CITY OF ALAMEDA RESOLUTION NO. _____

RESOLUTION APPROVING THE MASTER INFRASTRUCTURE PLAN (MIP) ESTABLISHING THE REQUIREMENTS AND STANDARDS FOR THE BACKBONE INFRASTRUCTURE TO SUPPORT THE REDEVELOPMENT AND REUSE OF ALAMEDA POINT.

NOW, THEREFORE, BE IT RESOLVED that the City Council approve the MIP (Exhibit A) and the Addendum Sheet (Exhibit B).

UPDATED DRAFT Master Infrastructure Plan

FIGURE 11 FLOOD PROTECTION 24" SEA LEVEL RISE

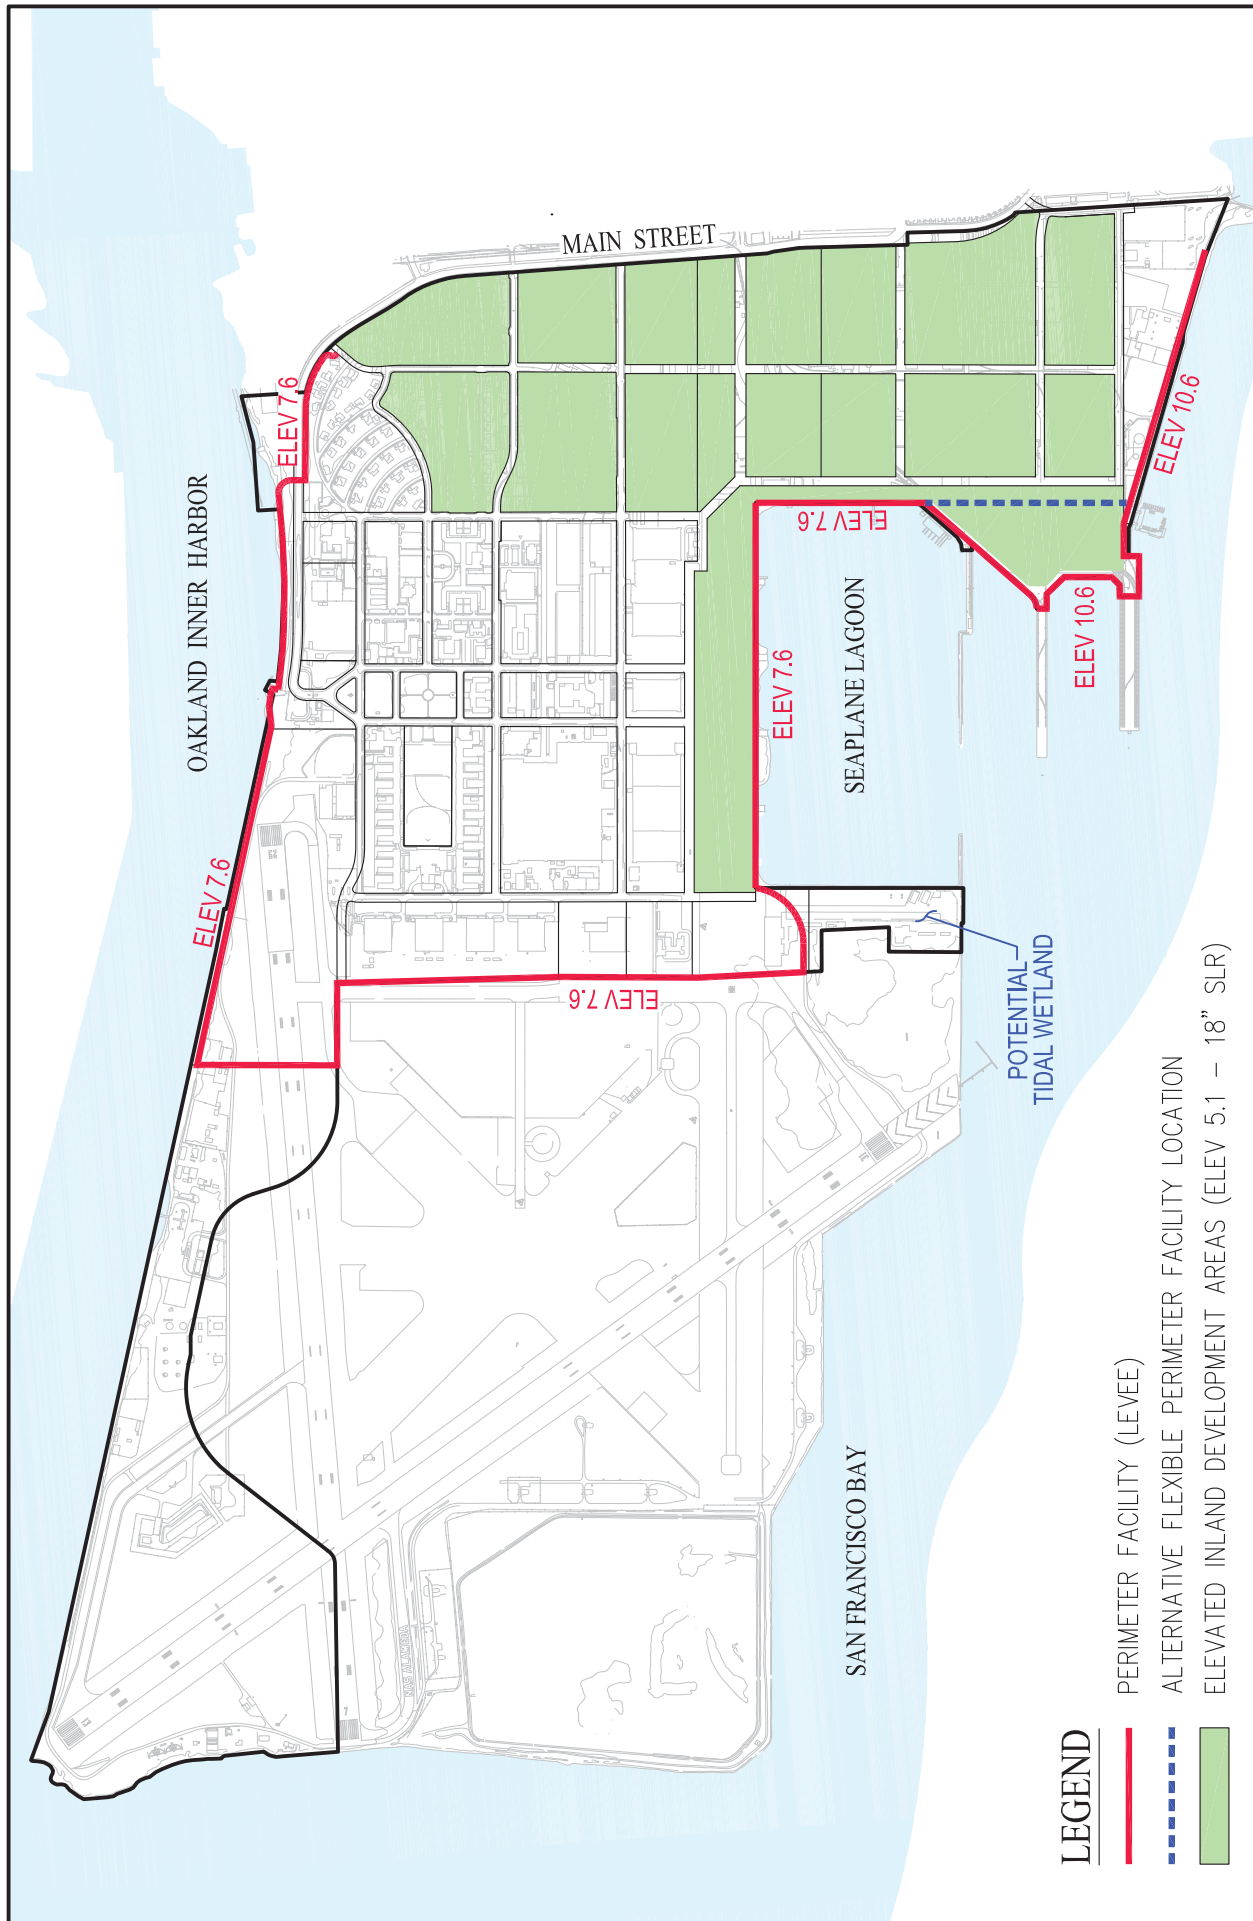
Revise Figures 11, 13 and 14 to depict updated initial flood protection system.

FIGURE 24
WEST REDLINE AVENUE EXTENSION
REUSE AREAS

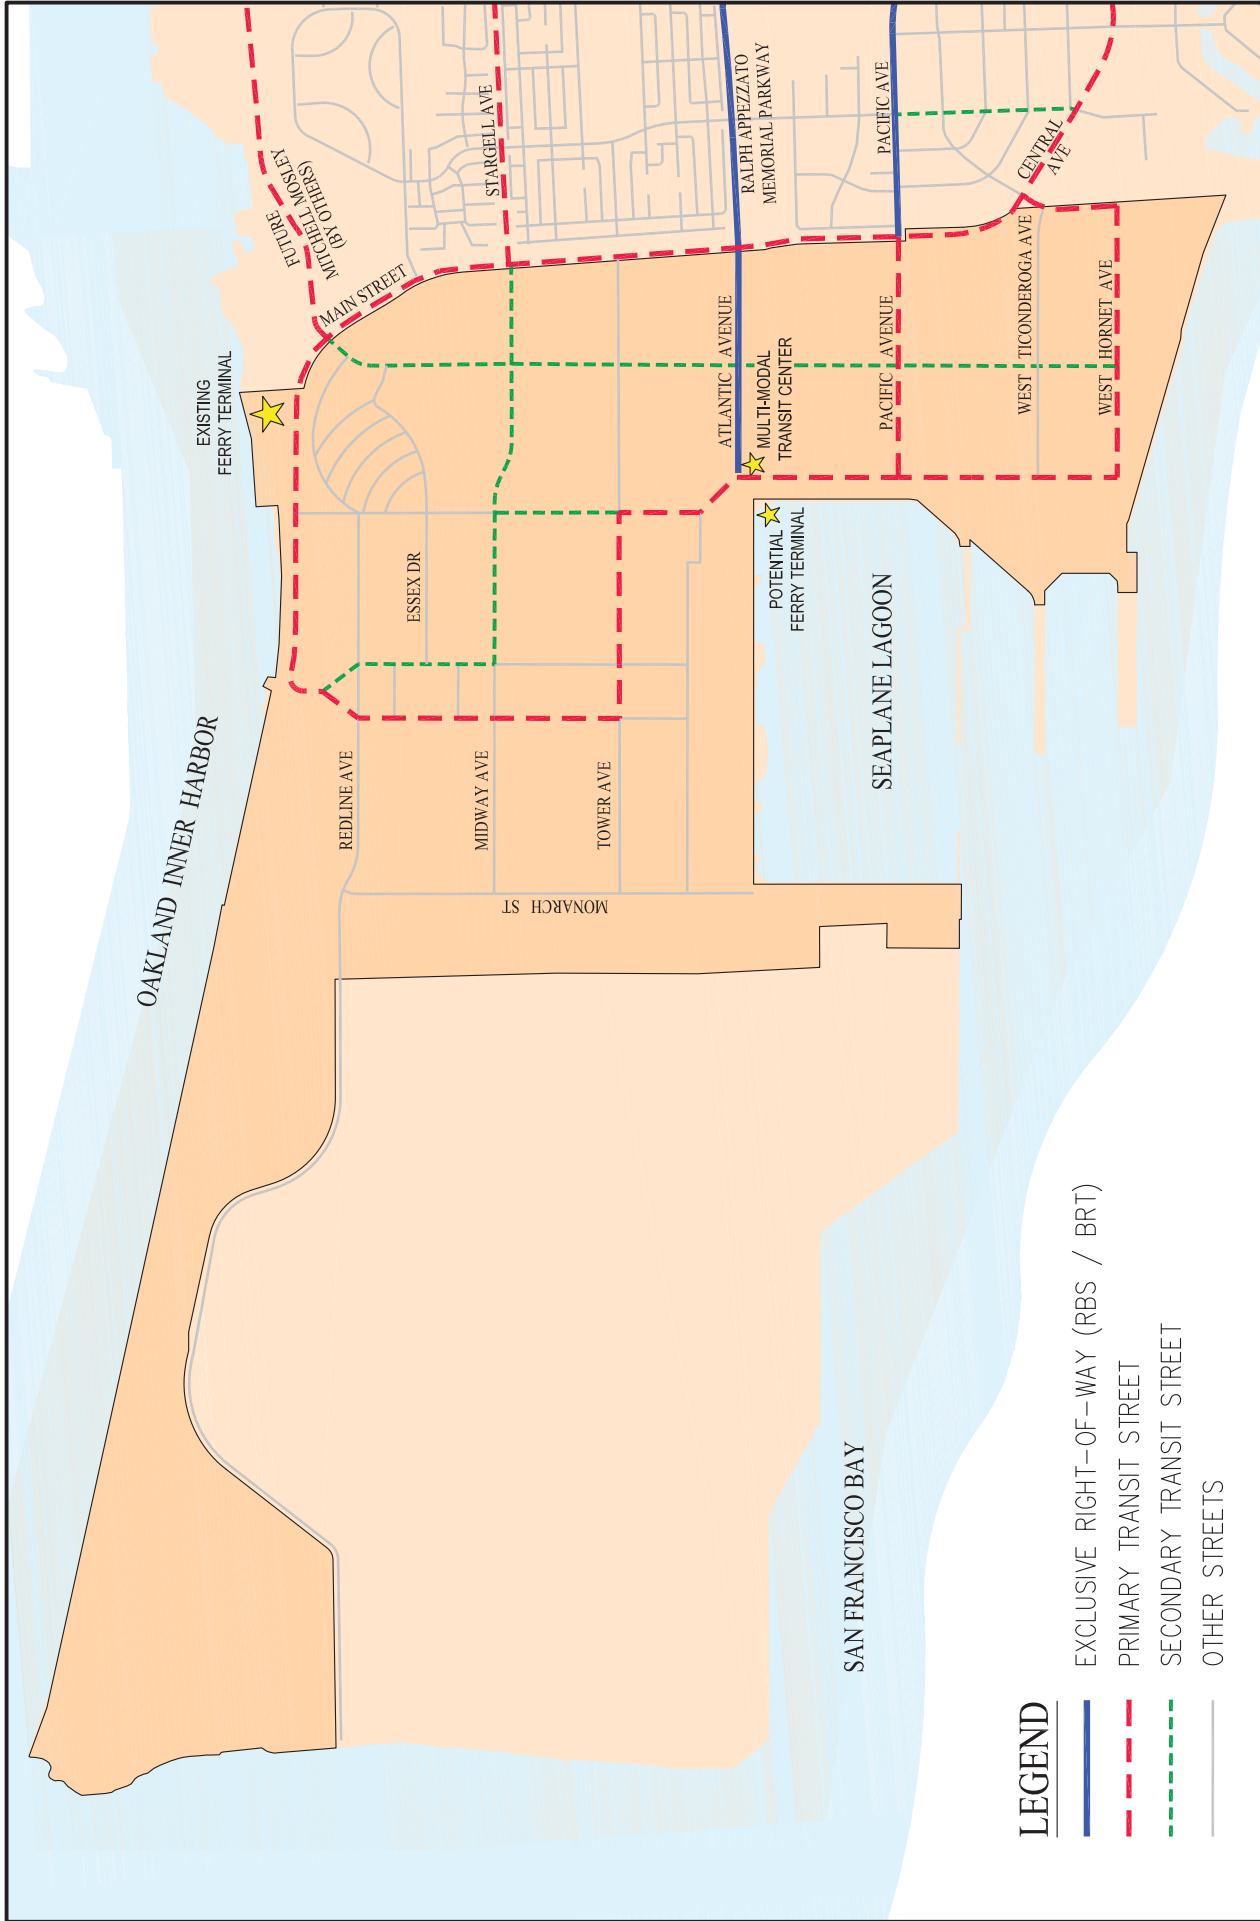
Add Figure 23, West Redline Extension.

FIGURE 27
PROPOSED TRANSIT
PRIORITY STREETS

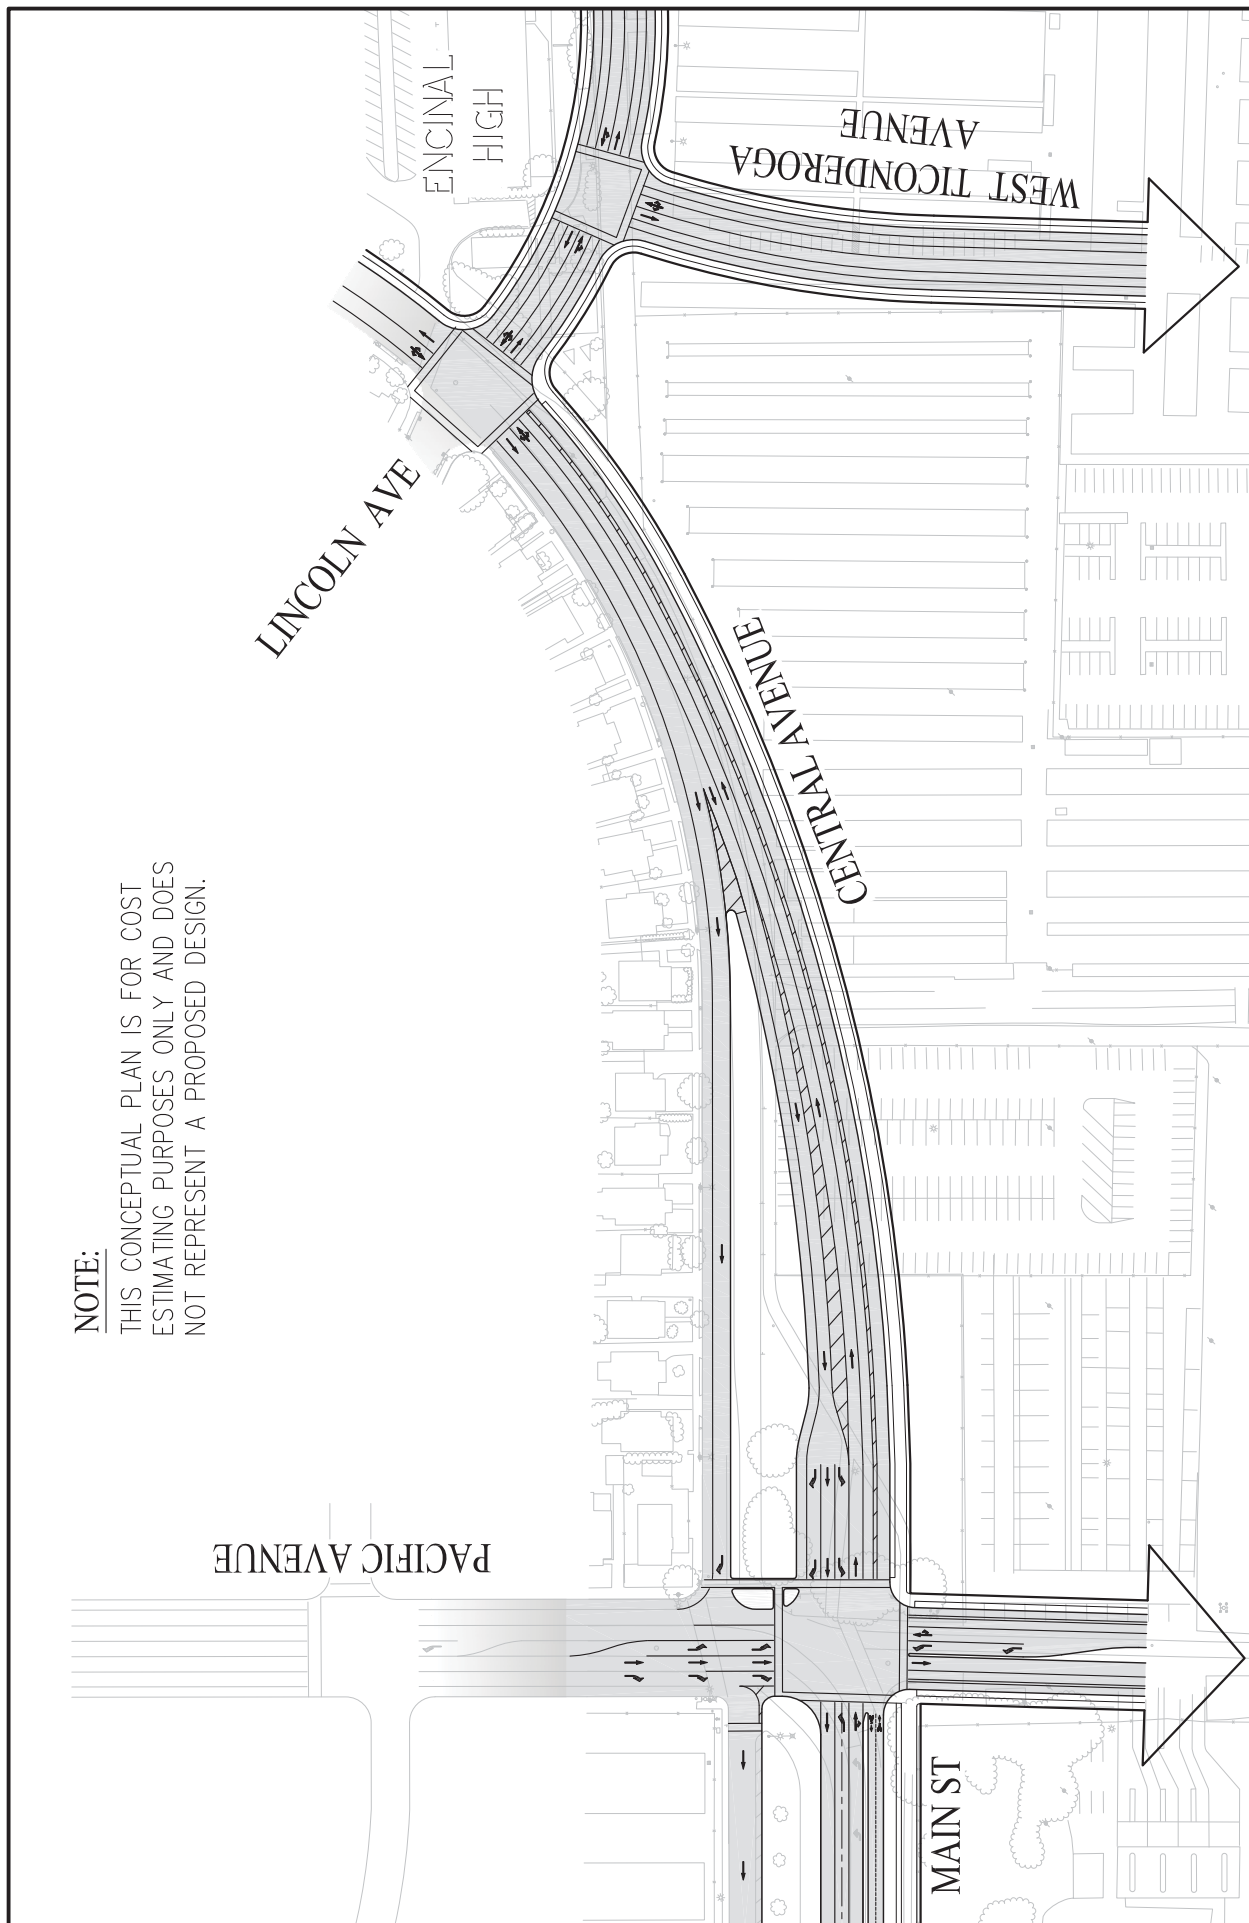
Modify Figure 27 to be titled “Proposed Transit Priority Streets.”
